TOWN OF GILBERT

DESIGN REVIEW BOARD STAFF REPORT

DR00-67 GREENFIELD MEDICAL DENTAL COMPLEX- SIGN

Greenfield Medical / Dental Complex - Sign Package

Exhibit A: Site Plan and Monument Sign Location

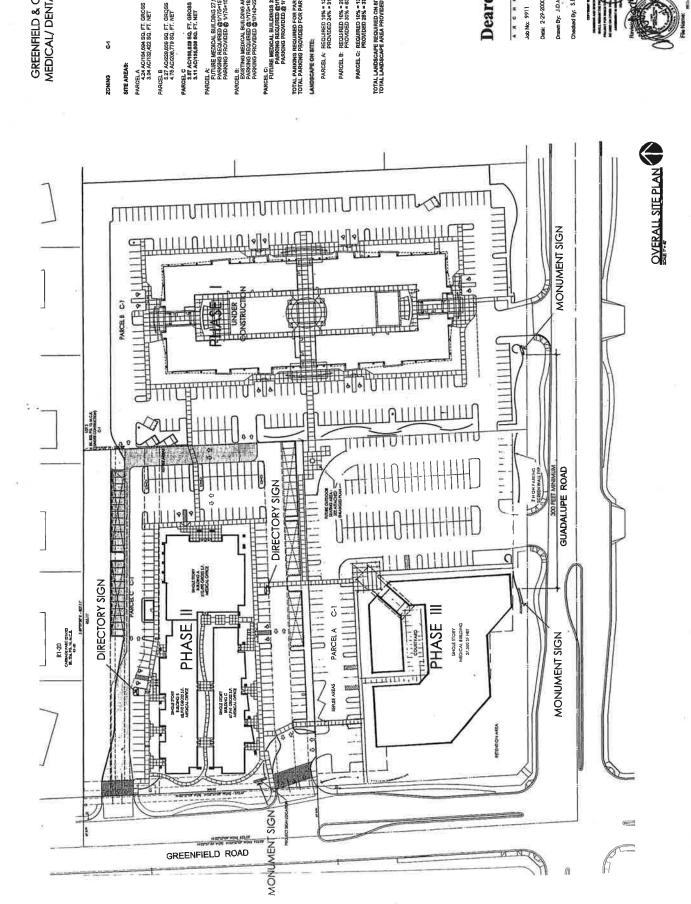
- 1. There shall be a minimum distance of 300' between monument signs.
- 2. All entry monument, directory, and tenant signage proposed for any future phase shall be submitted for review and approval by the Design Review Board.
- 3. Internally illuminated signs shall not be permitted on the north elevation of Phases I & Π .
